USB Power Delivery ENGINEERING CHANGE NOTICE

Title: FR_Swap State Operation

**Applied to: USB Power Delivery Specification Revision 3.0
V1.1**

Figure 8-105: Dual-Role Port in Source to Sink Fast Role Swap State Diagram

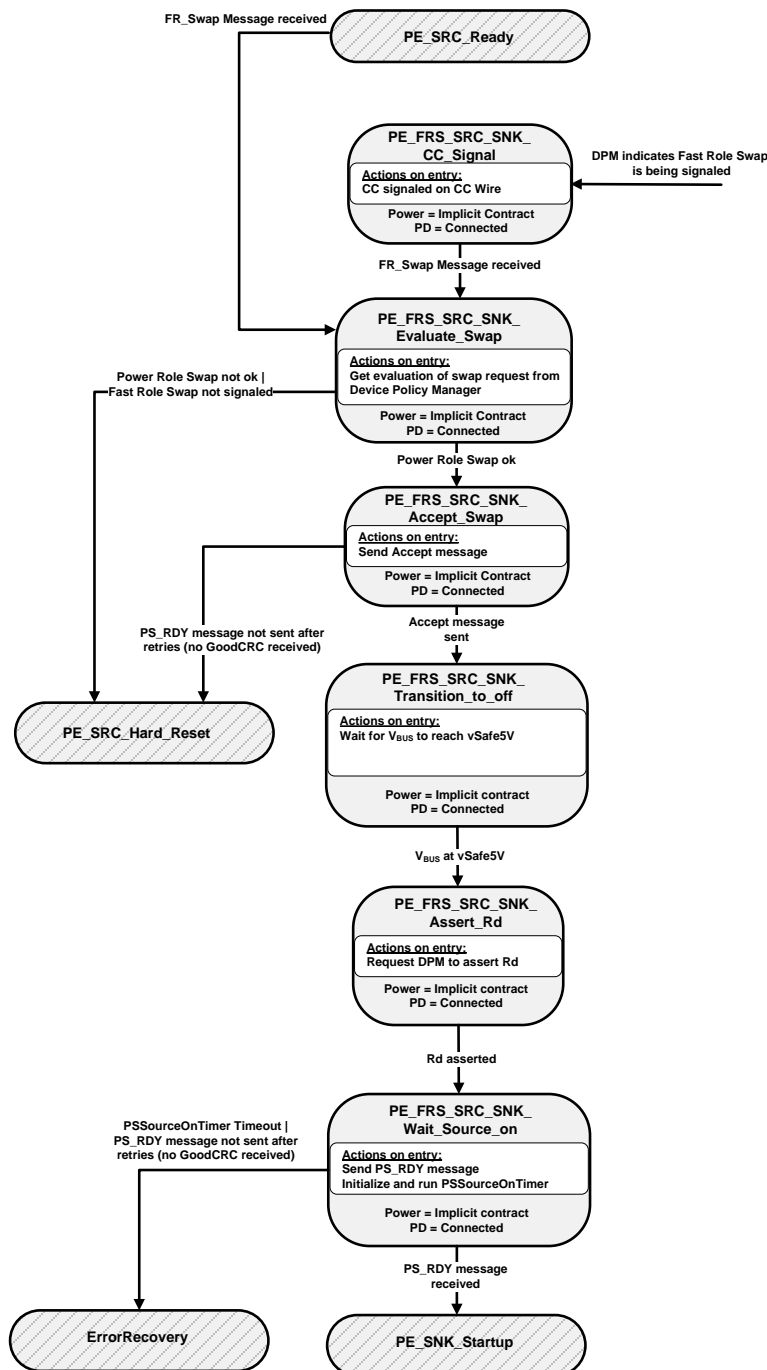
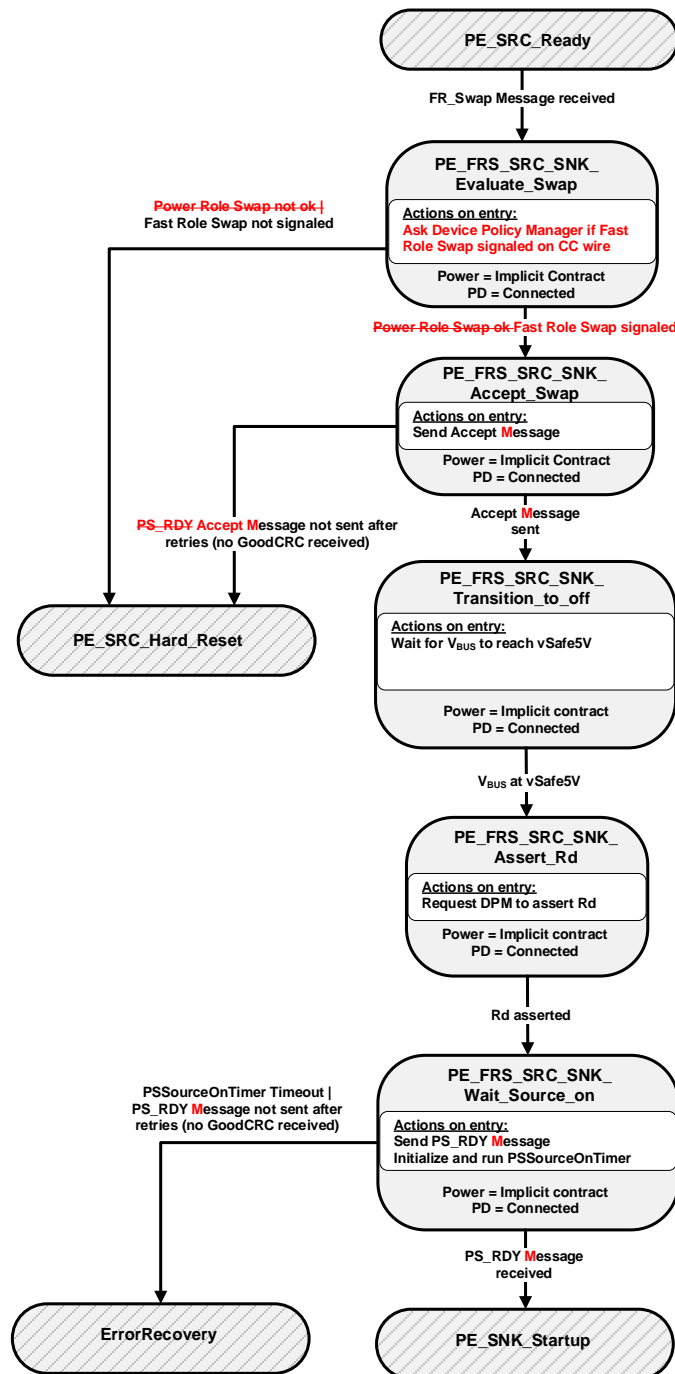
Once a Fast Role Swap capable Source has signaled Fast Role Swap on the CC wire it should accept any FR_Swap Message it subsequently receives. The revised state machine does not react to Fast Role Swap being signaled but instead always checks with the Device Policy Manager whether Fast Role Swap has been signaled on CC. The concept of a Fast Role swap being ok/not ok has been removed. Typos in the diagrams have been fixed.
--

This change simplifies the state machine, removing one state. It also assumes that an error occurs only if Fast Role Swap has not been signaled and FR_Swap has been received.
--

8.3.3.16.5.32 PE_FRS_SRC_SNK_Evaluate_Swap State

On entry to the **PE_FRS_SRC_SNK_Evaluate_Swap** state the Policy Engine *Shall* ask the Device Policy Manager whether ~~a Fast Role has been signaled on the CC wire~~~~Swap can be made~~.

- The Device Policy Manager indicates that a Fast Role Swap ~~has been signaled~~~~is ok~~.

- ~~• The Device Policy Manager indicates that a Fast Role Swap is not ok or~~
- The Device Policy Manager indicates that a Fast Role Swap is not being signaled.
